SERVICE BULLETIN

APPLICABILITY: 2019-21MY Forester
 2020-22MY Outback & Legacy
 2018-21MY Crosstrek

SUBJECT: 6/8-way and Driver's Seat Hinge Cover-
 Design Change

NUMBER: 12-299-20R
DATE: 09/04/2020
REVISED: 09/20/2021

Enlarged View of Damaged Claw

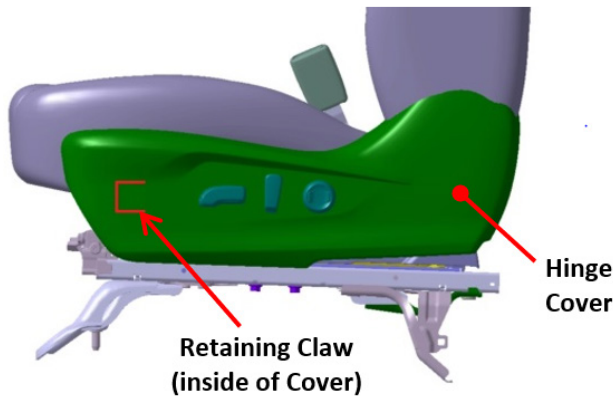
This bulletin announces a design change made to the outer hinge cover on the driver's 10-way adjustable power seats. The change has been made to address several reports about the cover coming loose over time as a result of getting into and out of the driver's seat. The retaining claw portion securing the cover to the seat frame has been changed to improve its strength and durability.
